LiDAR Quality Assessment Report

GA_SW Georgia 22 County Lidar_2017_B17 - Block 2

NGTOC
 2019-05-22
 S Ruhl

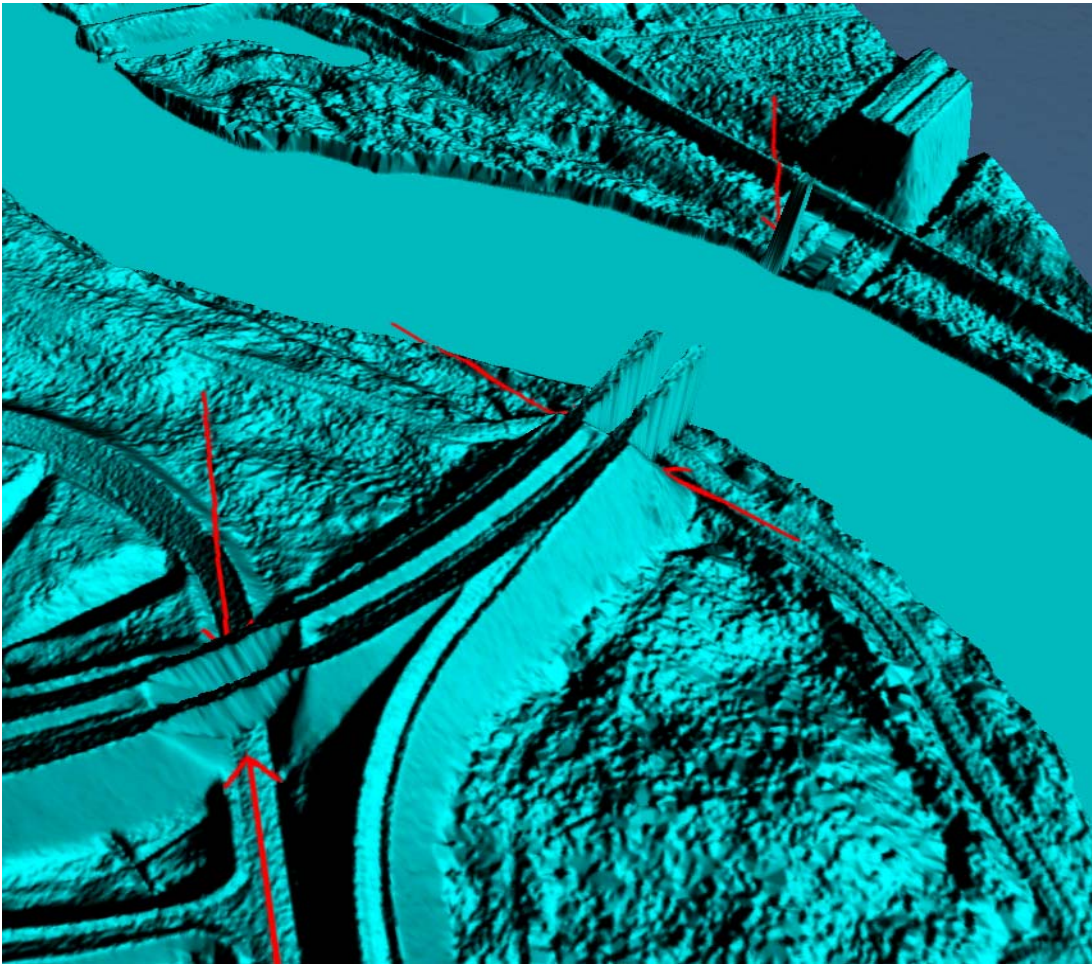
3 of 11 - bridge/finish bridge/deck removal @ 30° 54' 24.2909" N, 84° 35' 21.3280, W 30° 54' 16.9730" N, 84° 35' 14.2050" W, and 30° 54' 14.6221" N, 84° 35' 13.0243" W
CORRECTED
